Smith Drive/Louisville Drive Traffic Calming

**2021-11-18 Smith & Louisville Dr dwg Markups.pdf**

SMITH DRIVE/LOUISVILLE DRIVE TRAFFIC CALMING
 Smith Drive Plan Sheet - Louisville Drive to Dayspring Drive

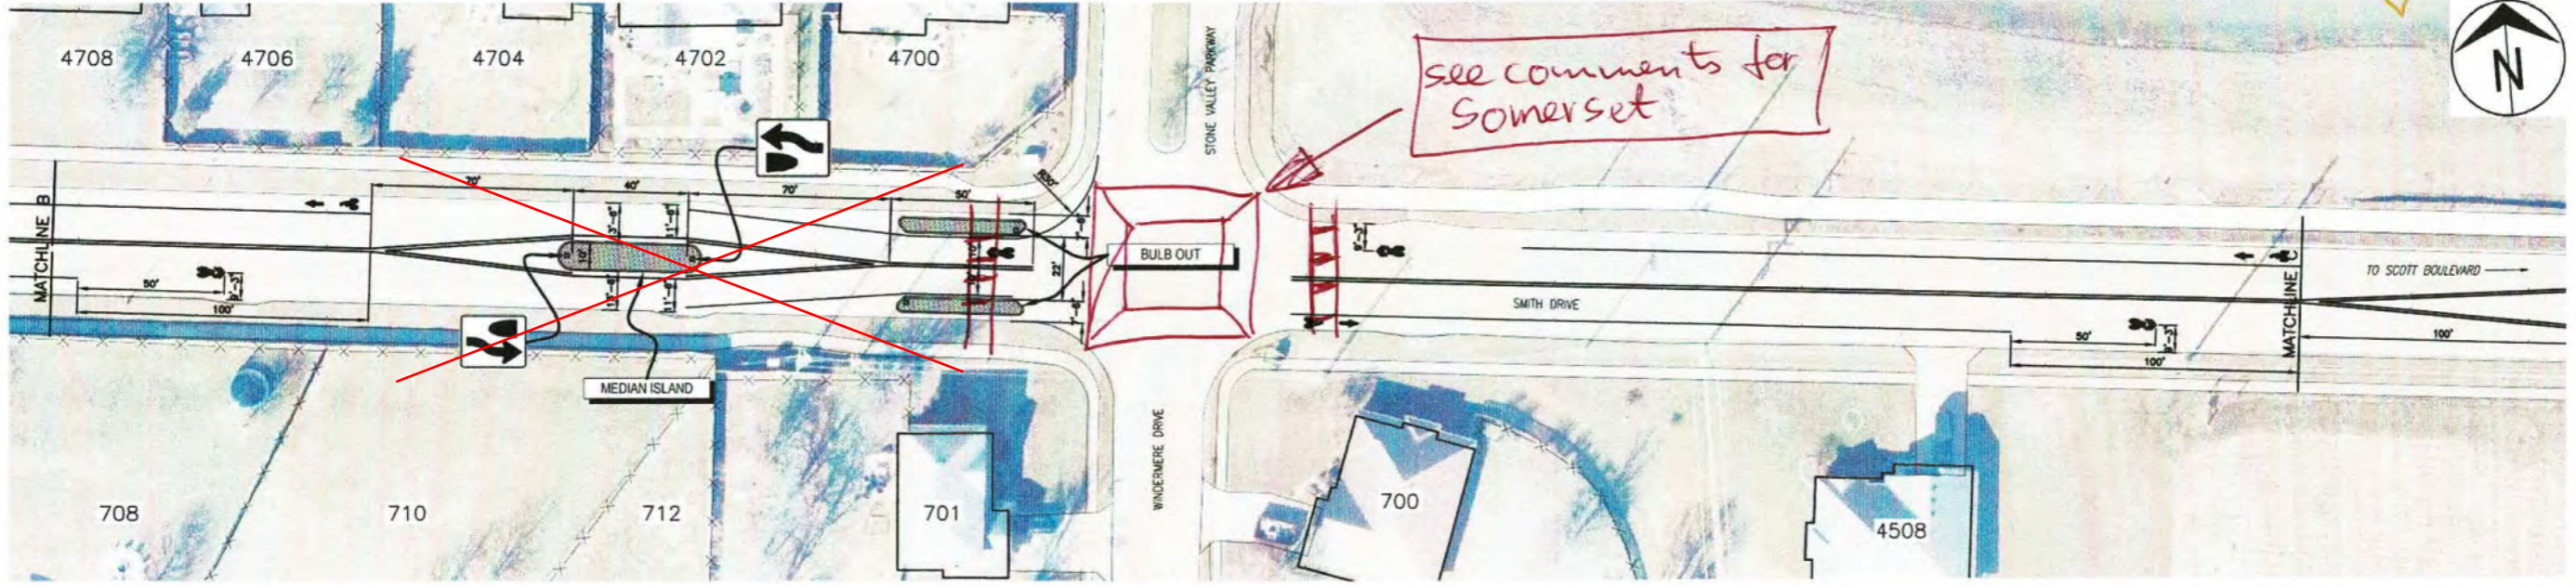
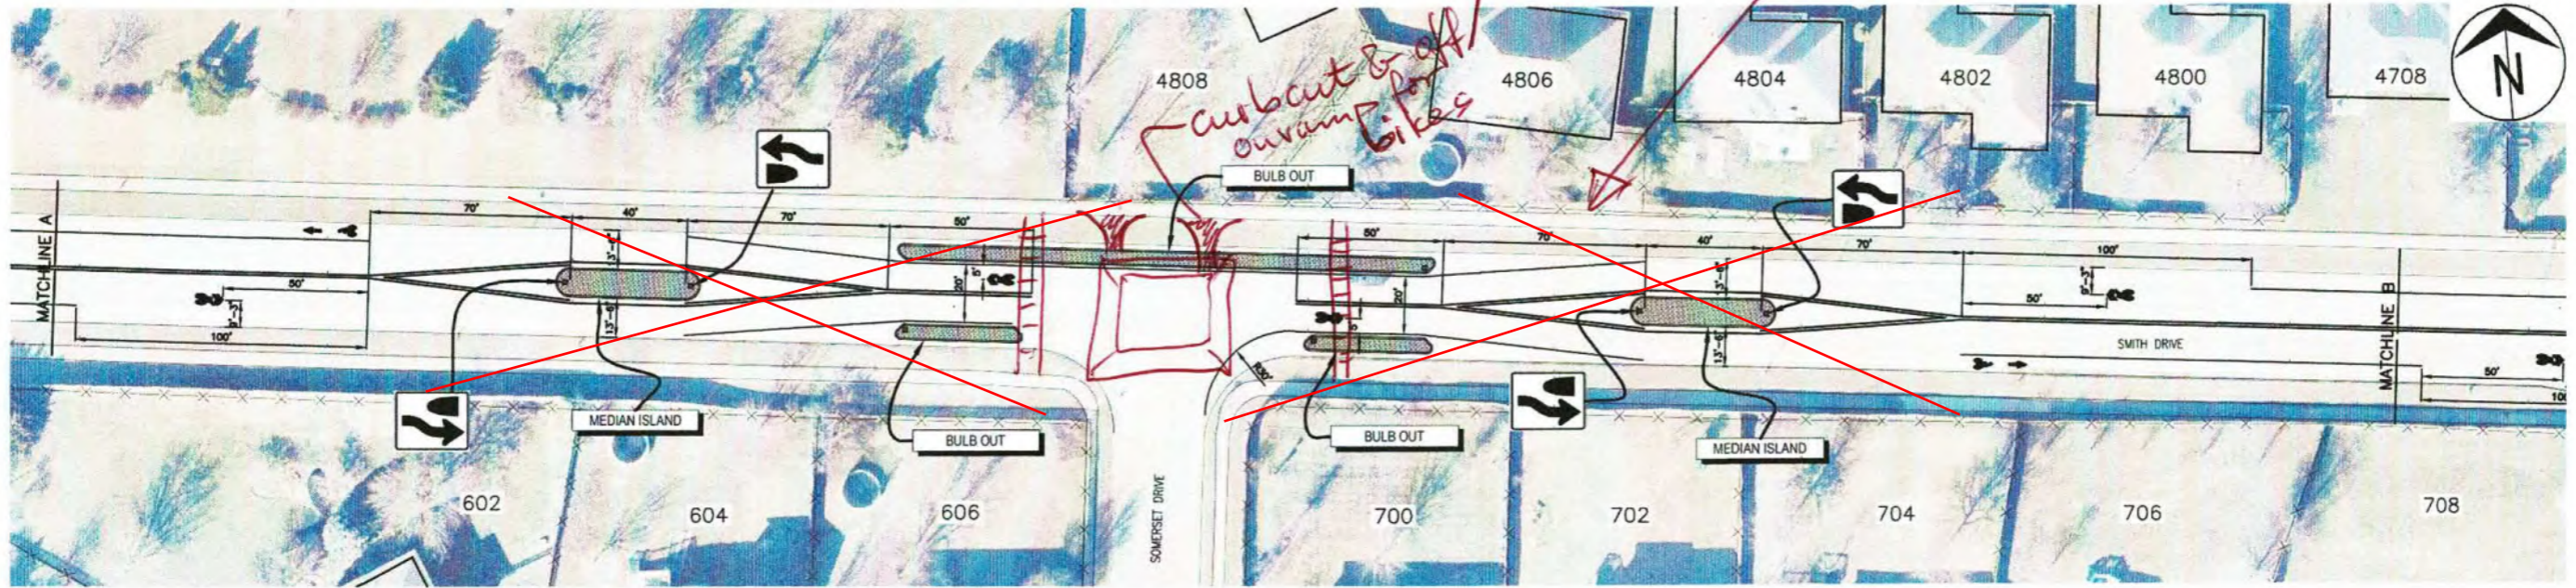
- This design forces bikes into the driving lane. 85% speed is >45mph → unsafe!
 - Makes snow removal difficult
 - Low visibility EB due to vertical curve
 → Add Xwalks on Smith Dr. & Speed Table
 Current design looks dangerous
 - Also provide "off" for bikes to/from Somerset to N Smith Dr. SW

This is going to develop, provide X walk now

consider straightening SW at dead tree stump

**SMITH DRIVE/LOUISVILLE DRIVE
TRAFFIC CALMING**
Smith Drive Plan Sheet - Dayspring Drive to Scott Boulevard

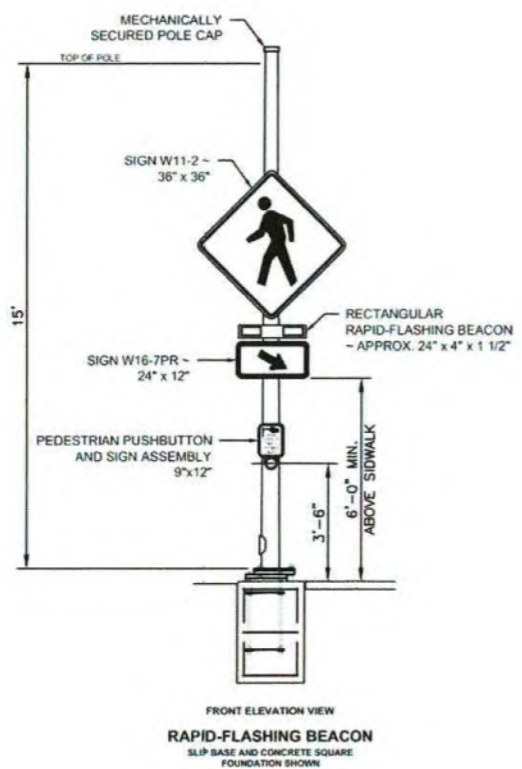
Narrow driving lanes as needed to stripe Bike paths to intersection. It is dangerous to merge w/ 45+ mph traffic.

LOUISVILLE DRIVE — RAINBOW TROUT DRIVE
1" = 20'

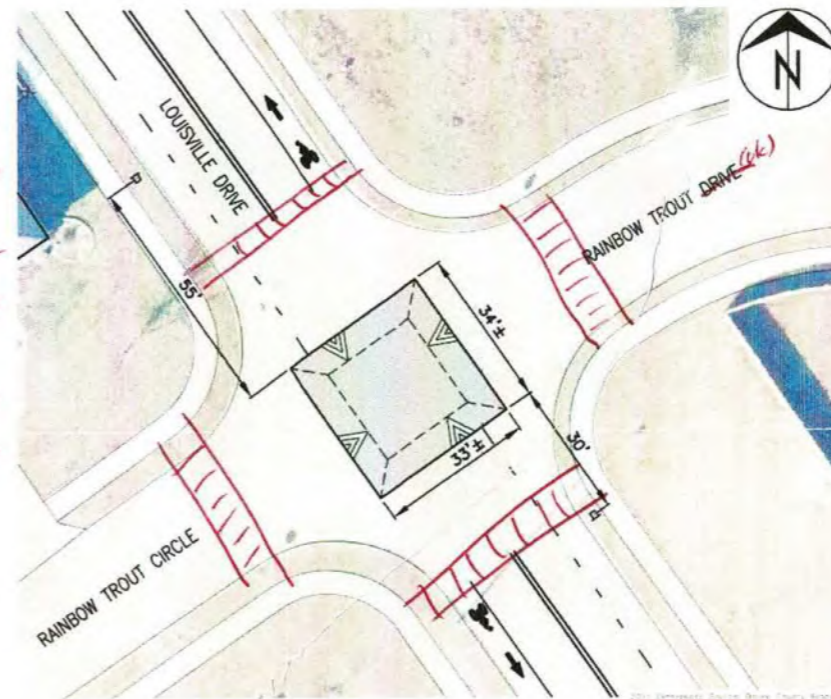
Add 4
Xwalks
Both Louisville
& Rainbow Trout
Dr. are
cut-throughs
in dense neigh-
borhood

LOUISVILLE DRIVE — RAINBOW TROUT CIRCLE
1" = 20'

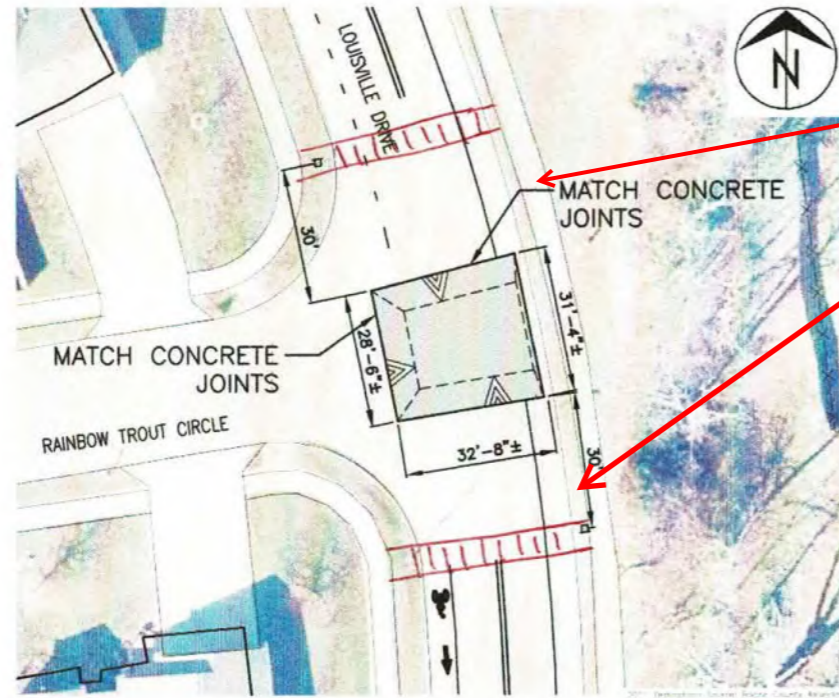
Visibility an issue due to horizontal curve → add Xwalks

LOUISVILLE DRIVE — LABRADOR DRIVE
1" = 20'

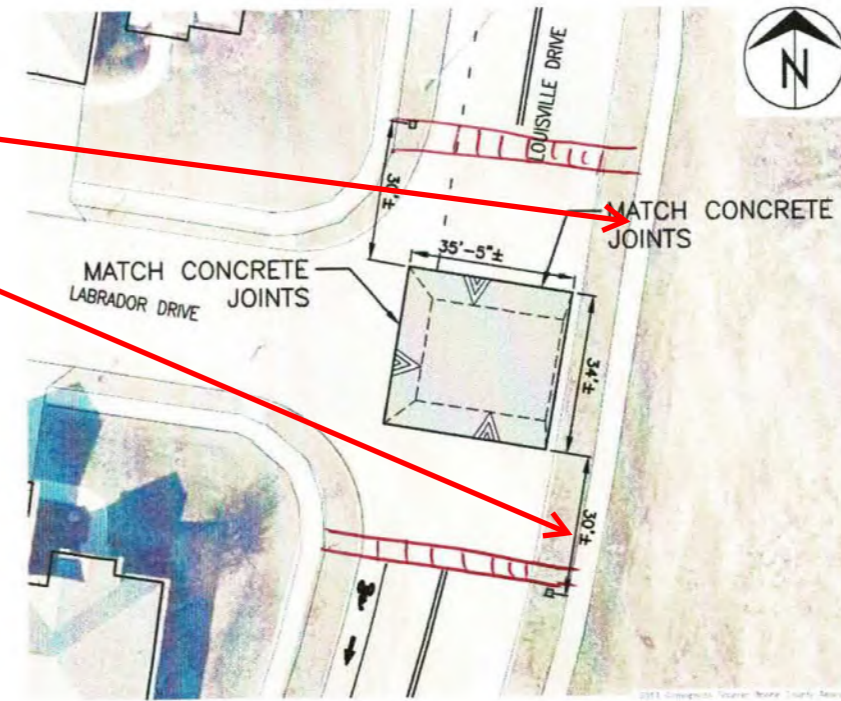
Add bike on/off ramps to SW. Not needed if Xwalks are constructed.

LOUISVILLE DRIVE — TIPTREE COURT
1" = 20'

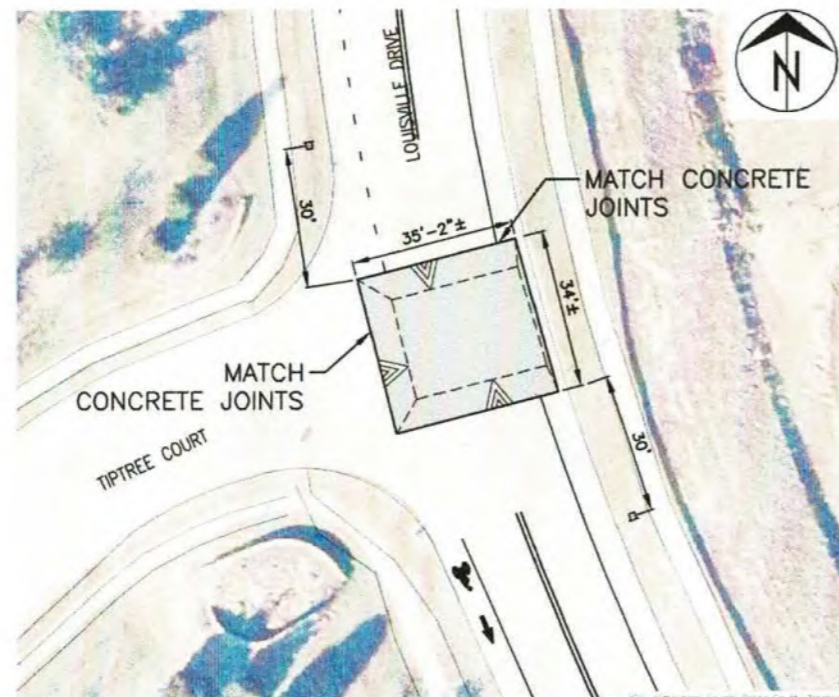
Low visibility due to vertical curve → add Xwalks
